### **Amendment to the Drawings**

This is responsive to the Office Action mailed December 7, 2005. The amendments and remarks herein are proper, are supported by the specification, and do not include new matter.

**FIG. 15**

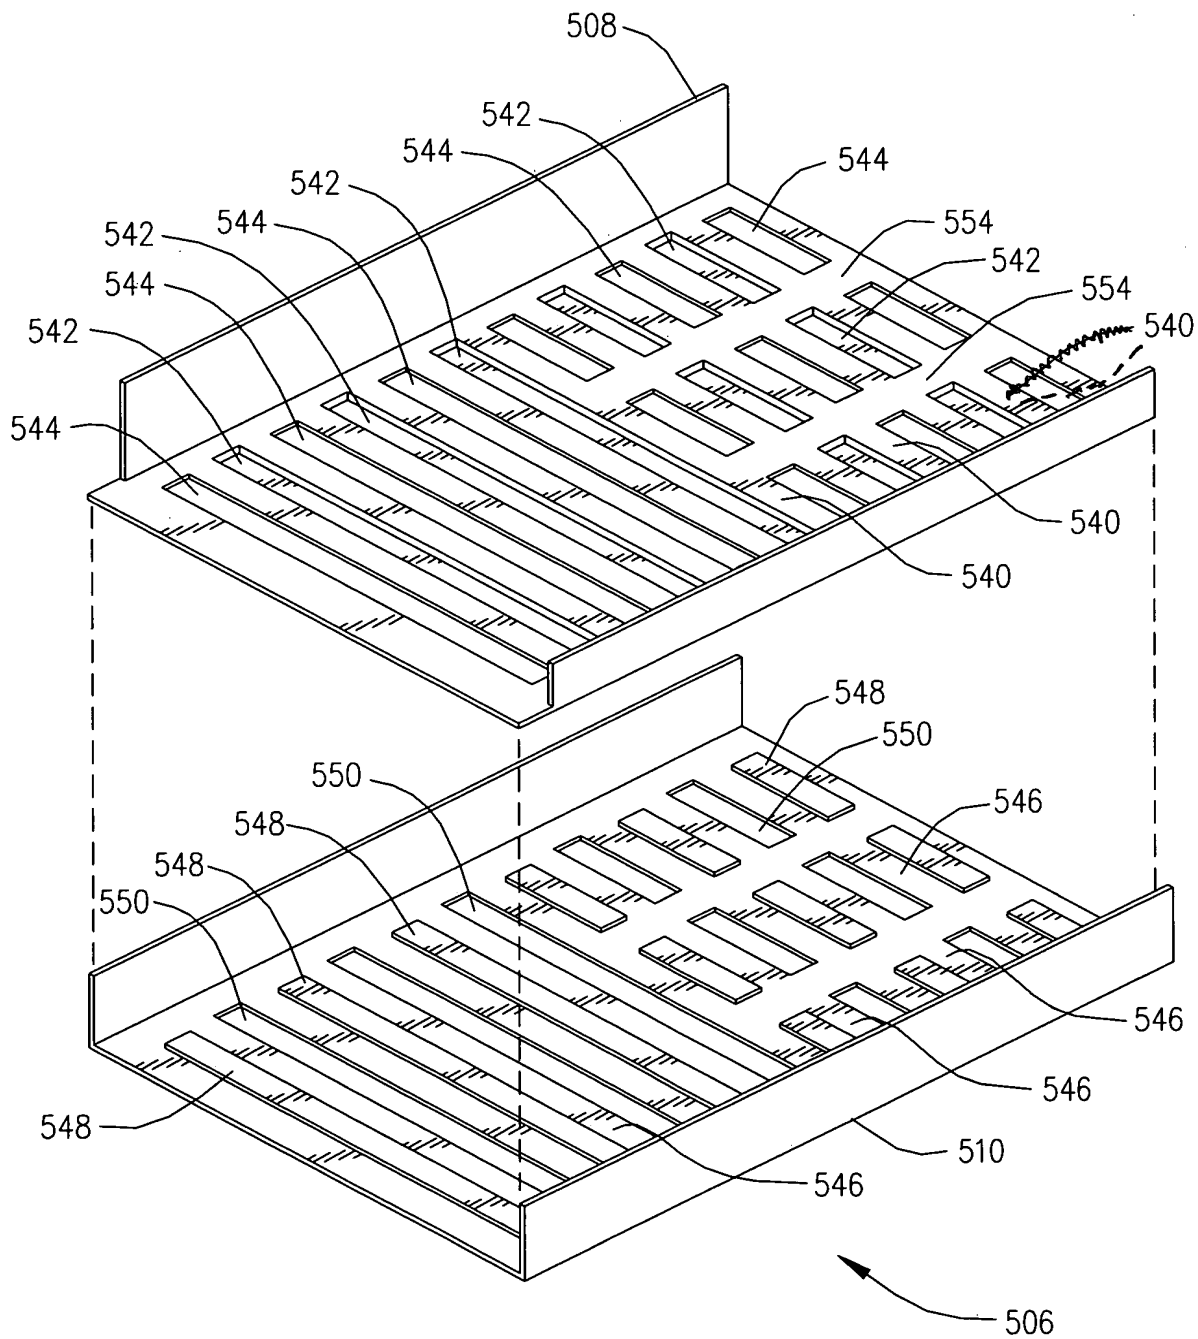
The attached sheet of drawings includes an amendment to FIG. 15. FIG. 15 has been amended to make the lead line for item 540, planar surface, a hidden lead line because the planar surface 540 is hidden in this isometric view.
